Land North And East Of Stakehill Industrial Estate, Middleton Transport Assessment Review

Technical Note 01

National Highways / WSP

23rd May 2025

Figure 2 Transport Assessment, Safety Assessment, Study Area

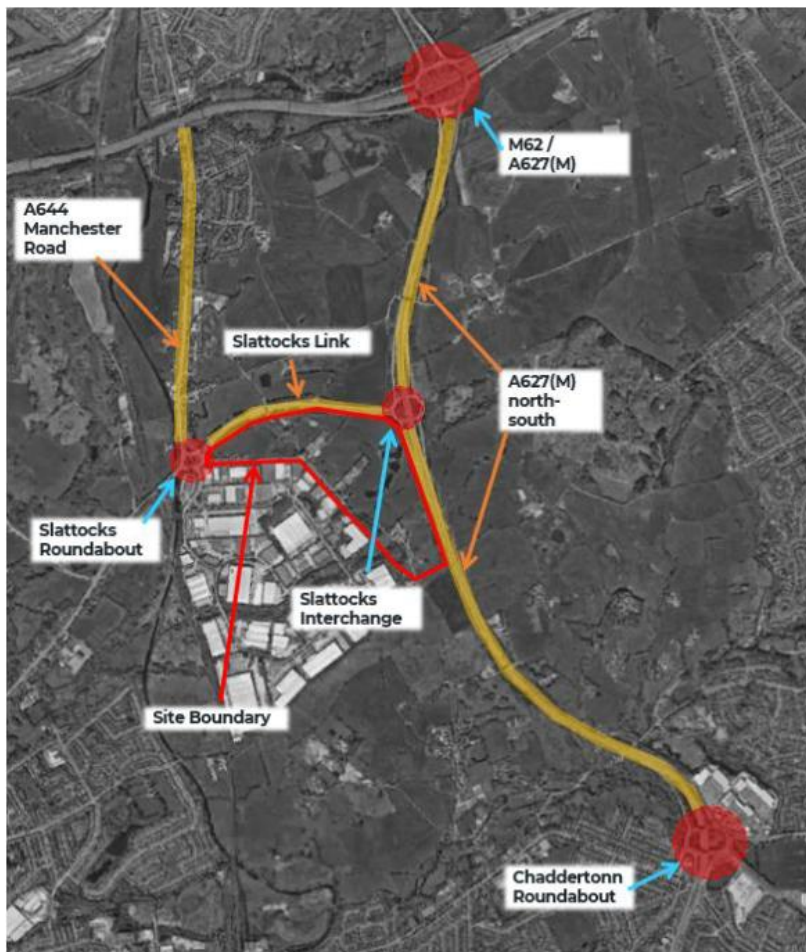
- 2.5 The TA reported on Personal Injury Collisions from Crashmap covering a five-year period (2018, 2019, 2020, 2021, and 2022).
- 2.6 AECOM advises that the COVID-19 pandemic should be taken into account, and the years affected by the pandemic are removed from the assessment (2020 and 2021). This is because these years are considered inappropriate and not representative of typical road conditions. This is considered **MINOR**.

- 2.7 AECOM would therefore recommend that 2017 and 2023 (the latest available on Crashmap) be added to the assessment.
- 2.8 AECOM also note that the defined road network extent does not include the slip roads approaching the SRN junctions, namely Junction 19, 20, and the Slattocks Interchange. Collision data along these slip roads is critical for understanding existing safety conditions, particularly in relation to traffic queues potentially extending back onto the SRN mainline carriageways. This is especially relevant given the potential for increased future traffic demand to exacerbate such conditions. This is considered **MINOR**.

Figure 5 M62 and A627(M) potential improvements locations

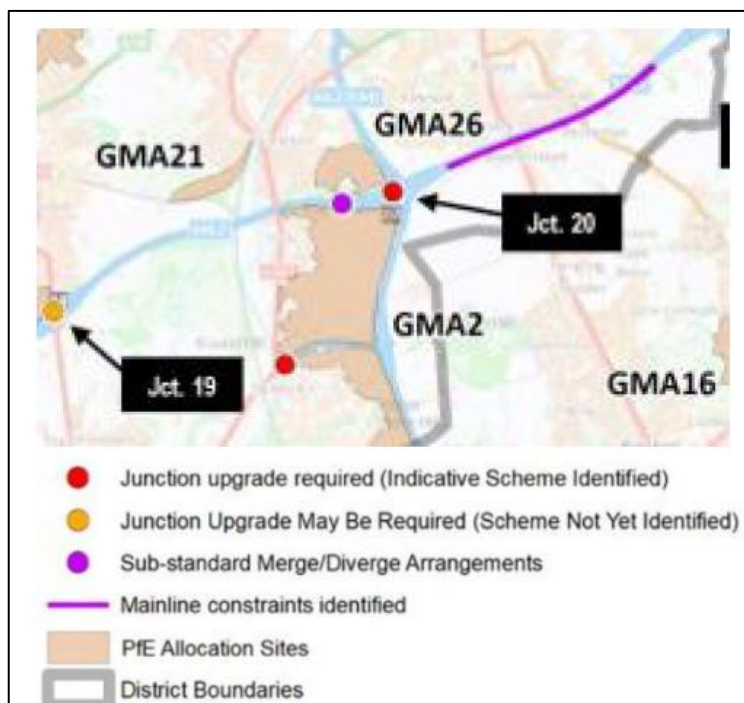
- 5.3 The EIA Scoping Review states that the TA should identify any necessary mitigation measures. AECOM understands that National Highways agreed to the interventions identified in the *Places for Everyone* (PfE) assessment (as shown in Figure 5) should be used as a starting point to develop more detailed mitigation proposals and delivery requirements.

- 5.4 Nonetheless, the TA does not meet the requirements of the scoping agreement. The assessment demonstrates that the initially proposed mitigation measures would be insufficient to address the impact on the Strategic Road Network (SRN). Furthermore, no assessment has been provided regarding the suitability of the M62 Junction 20 merge and diverge layouts, as required under the Design Manual for Roads and Bridges (DMRB). This is considered **SIGNIFICANT**.
